Technical Service Bulletin

SUBJECT:			No: TSB-10-13-002
DTCs P0657, P1590, U0101, U0100, P0201 – P0206 & POSSIBLE NO START (U.S. ONLY)			DATE: January, 2010
			MODEL: See Below
CIRCULATE TO:	<input type="checkbox"/> GENERAL MANAGER	<input checked="" type="checkbox"/> PARTS MANAGER	<input checked="" type="checkbox"/> TECHNICIAN
<input checked="" type="checkbox"/> SERVICE ADVISOR	<input checked="" type="checkbox"/> SERVICE MANAGER	<input checked="" type="checkbox"/> WARRANTY PROCESSOR	<input type="checkbox"/> SALES MANAGER

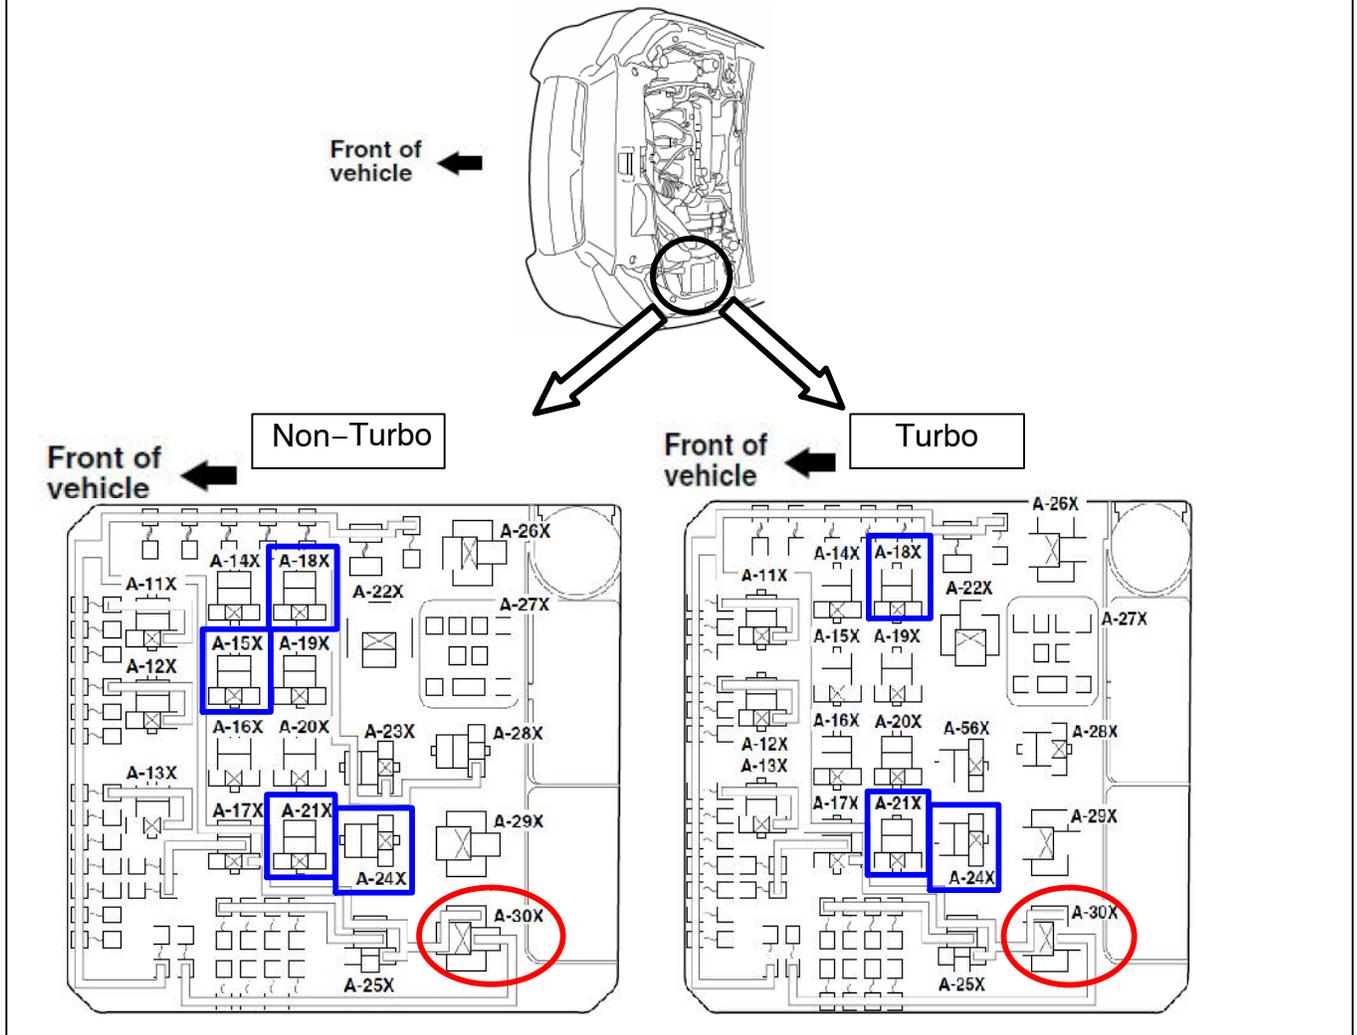
LANCER and LANCER SPORTBACK			
Connector No.	Name	Correct Part no.	Remarks
A-15X	CVT control relay	8627A024	Shown as 
A-18X	Throttle actuator control motor Relay		
A-21X	Injector Relay		
A-24X	Starter Relay		
A-30X	MFI Relay	MR400709	Shown as

OUTLANDER

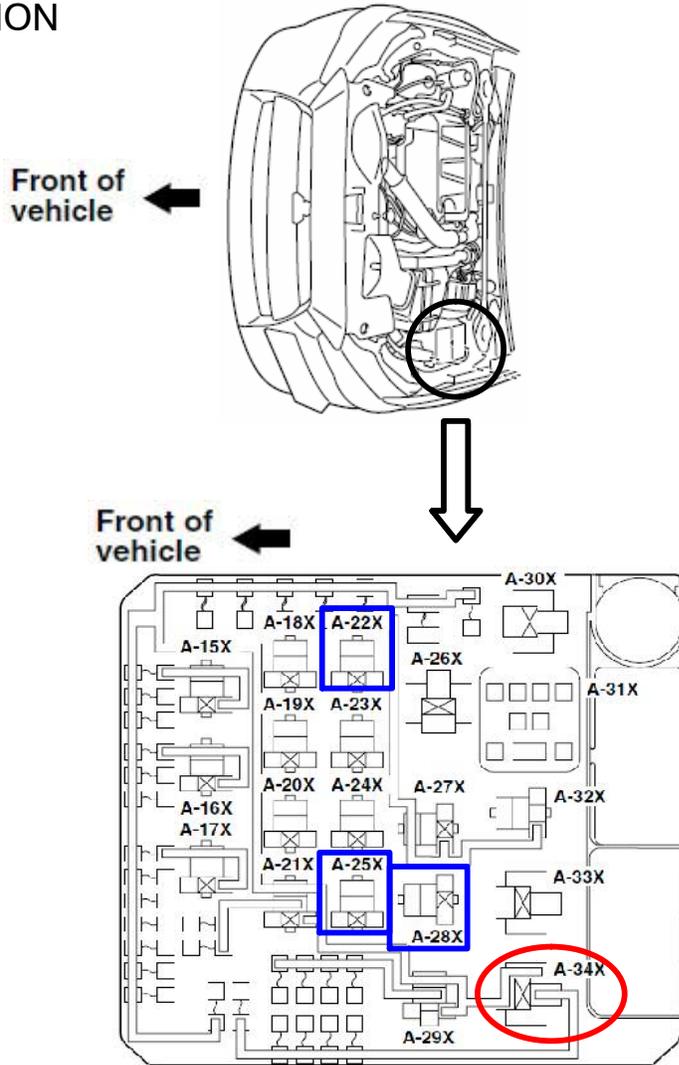
Connector No.	Name	Correct Part no.	Remarks
A-18X	A/T control relay (3.0L Engine)	8627A024	Shown as 
	CVT Control Relay (2.4L Engine)		
A-21X	Throttle actuator control motor Relay		
A-24X	Injector Relay		
A-27X	Starter Relay		
A-33X	MFI Relay	MR400709	Shown as

LANCER EVOLUTION

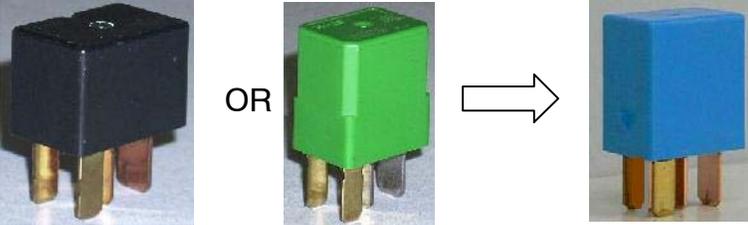
Connector No.	Name	Correct Part no.	Remarks
A-22X	Throttle actuator control motor Relay	8627A024	Shown as 
A-25X	Injector Relay		
A-28X	Starter Relay		
A-34X	MFI Relay	MR400709	Shown as
